**HISTORIC PRESERVATION REVIEW BOARD
STAFF REPORT AND RECOMMENDATION**

Landmark/District:	Capitol Hill Historic District	<input checked="" type="checkbox"/> Agenda
Address:	630 G Street SE	<input type="checkbox"/> Consent
		<input checked="" type="checkbox"/> Concept
		<input checked="" type="checkbox"/> Alteration
Meeting Date:	December 21, 2023	<input type="checkbox"/> New Construction
Case Number:	23-574	<input type="checkbox"/> Demolition
		<input type="checkbox"/> Subdivision

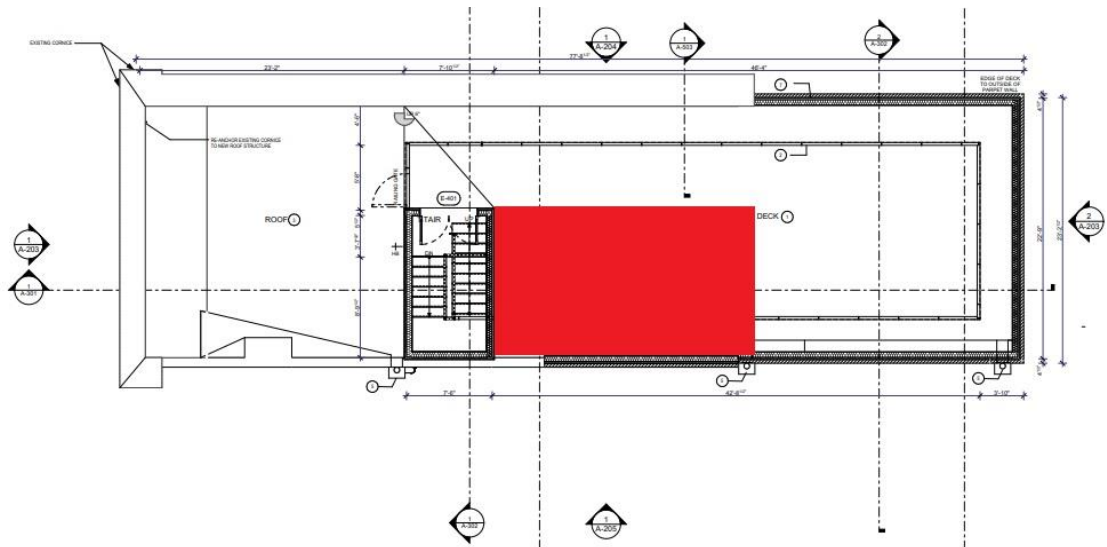
The revisions to the roof deck were mainly inspired by the Board's desire to have activity atop the roof deck not visible to observers standing in the front yard of the neighboring church. The changes include:

- 1) The penthouse roof has been lowered 6 ½" (from 46' 6 ½" above ground level to 46')
- 2) The proposed roof height has been lowered 6 ½" (from 38' 6 ½" to 38')
- 3) The roof deck has been lowered approximately 3" by using the roof as the deck (Duradek style) rather than having a roof deck sleeper system
- 4) The setback of the deck railing from the parapet has been increased by about 2' (from 2' 6 ½" to 4' 6")
- 5) The cornice has been simplified on the new rear addition
- 6) The parapet height of the rear addition has been lowered approximately 1" (from 41' 11" to 41' 10").

Taken together, the height of the roof deck has been lowered by approximately 16" while maintaining nearly the same parapet height. The penthouse stair and deck remain in the same location.
